VTech Telecommunications Ltd

Request for Class II Permissive Change

FCC ID:EW780-1920-00

Date: 2020-09-02

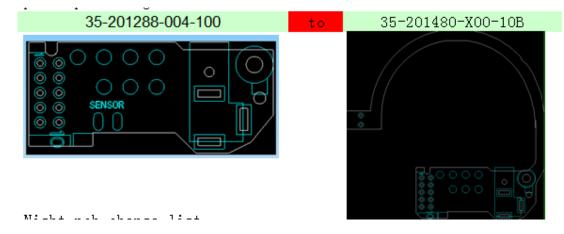
1. Based on original version to change the temperature sensor from outside to inside; See below photo;

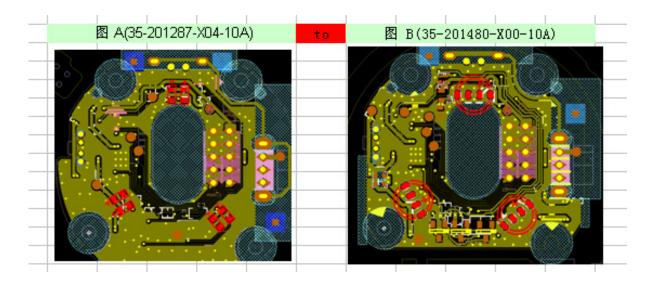
2. To change the temperature sensor from outside to inside, The PCB layout of power was updated from 35-201288-004-100 to 35-201480-X00-10B as below

A (35-201287-X04-10A)

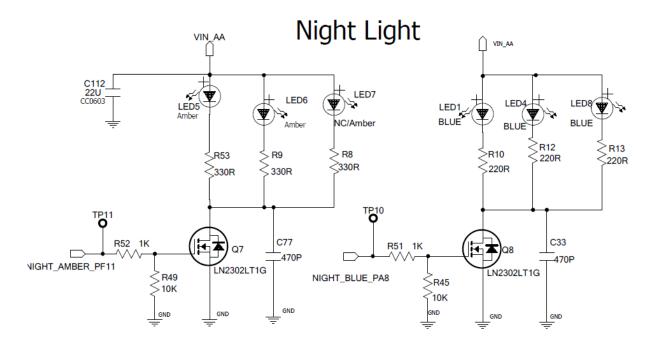
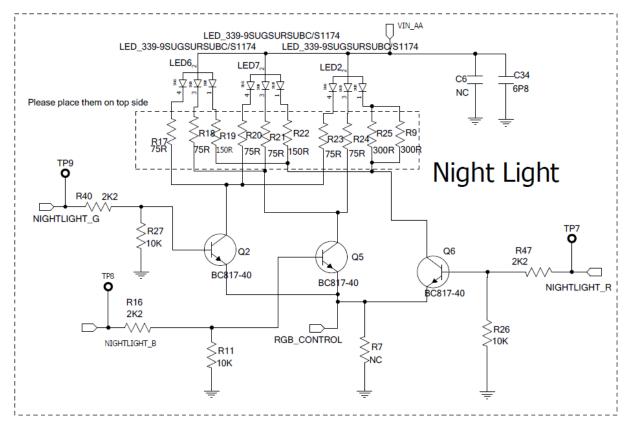
3.The PCB layout of Night Light was changed from surface Mounted technology component to through hole technology component, And the circuit was changed as from A (35-201287-X04-10A to B (35-201480-X00-10A). And the LED component from "19-217/S2C-AM2N2VY/3T(V) _LED5,LED6,LED7 " and 19-217/G7C-AP1Q2B/3T_LED1,LED4,LED8" to "YL5ARGB9UCK22/P17-H,_LED2,LED6,LED7".

New PCB parts: 35-201487-001-100 PCB:

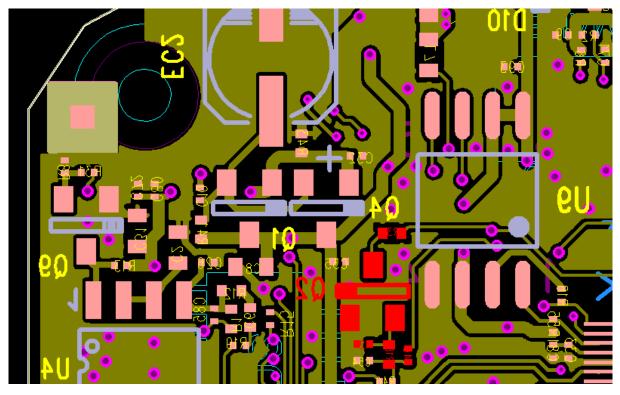
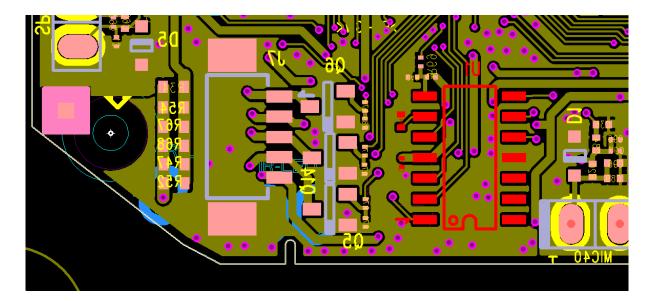
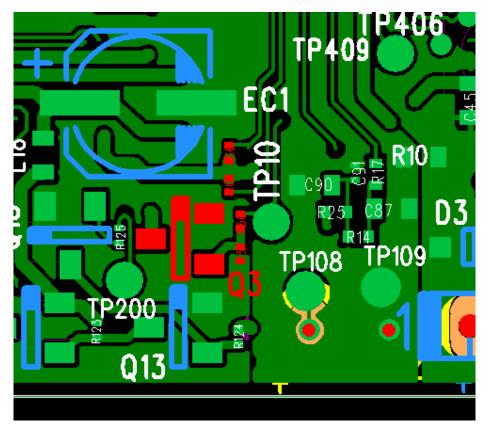
4. To control the Night sensor and Night light LED, the main PCB layout and circuit were updated and newly added parts as below in SCH&PCB (35-201487-001-100):
